Title TCS Laser Chiller Summing Board			
Size: A	DCC Number: D1500265		Ligo Project California Institute of Technology Massachusetts Institute of Technology 
Drawn by: Ben Abbott	Date: 11/16/2016	Revision: v2	
File: C:\restored\Ben\AOS\TCS Stuff\Laser Chiller Summing\LaserChillerSumming.SchDoc 11/16/2016 9:40:06 AM Sheet 1 of 2

Title Summing Node			
Size: A	DCC Number: D1500265		Ligo Project California Institute of Technology Massachusetts Institute of Technology
Drawn by: Ben Abbott	Date: 11/16/2016	Revision: v2	
File: C:\restored\Ben\AOS\TCS Stuff\Laser Chiller Summing\SummingNode.sch Dec 24:26 AM Sheet 2 of 2

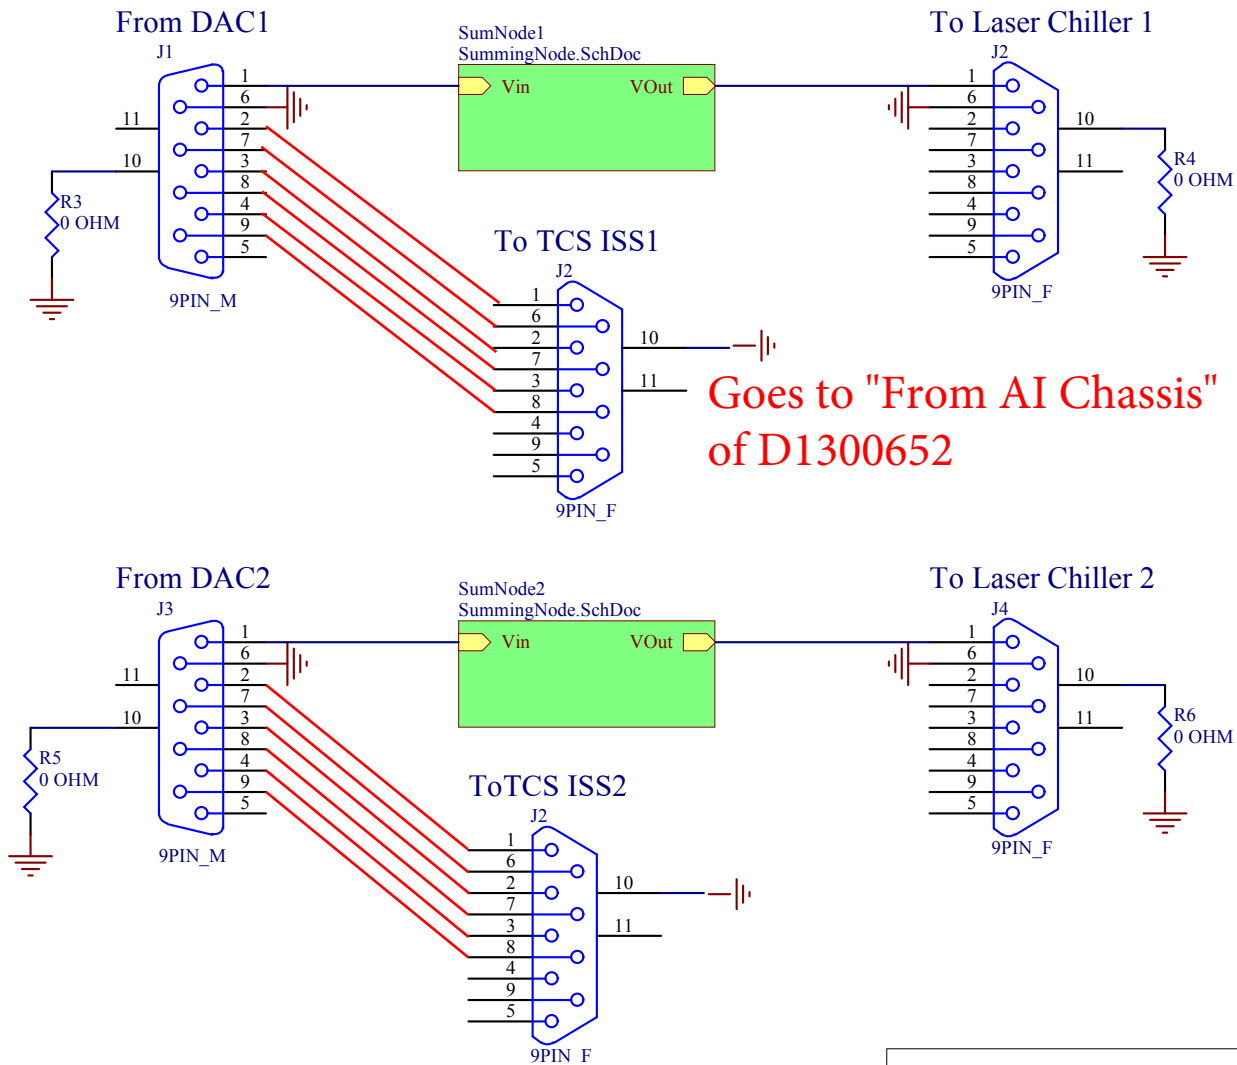
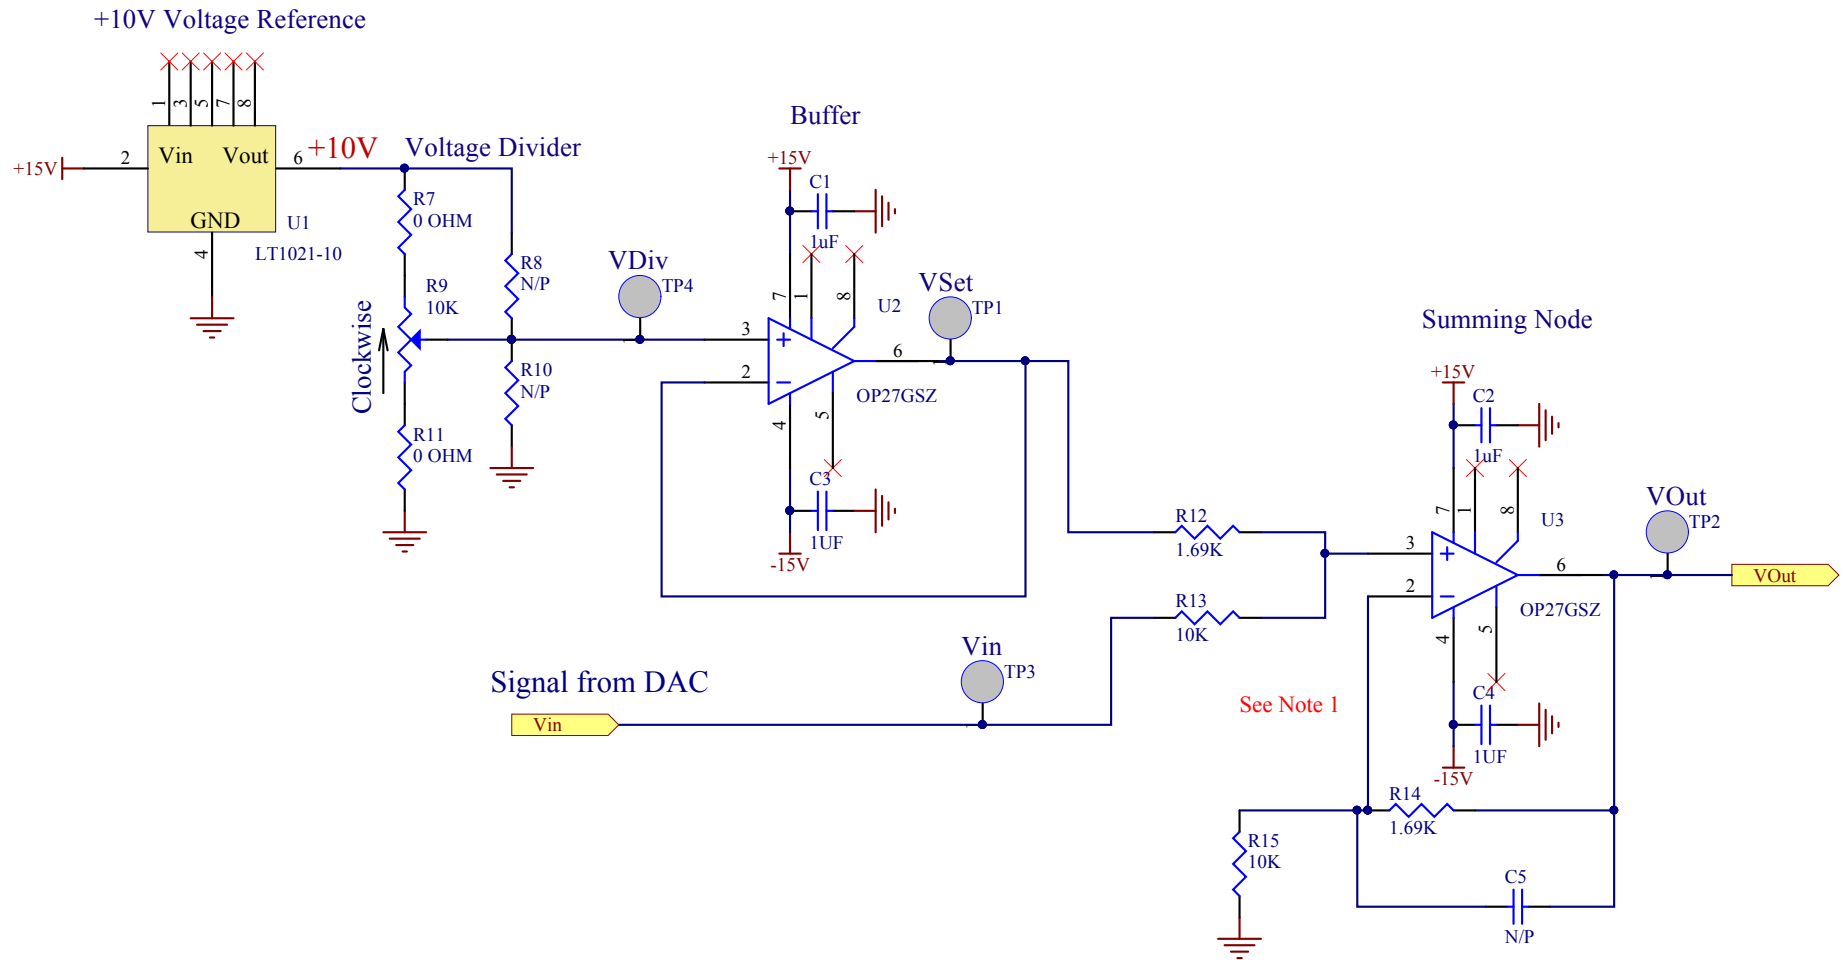
Add new TCS CO2 ISS breakout DB9s

Goes to "From AI Chassis" of D1300652

Note 1:
 R12, R13, R14 and R15 have been changed in order to reduce the gain of the DAC path to 0.17V/V. This was done to stop DAC reboots from tripping the chiller.
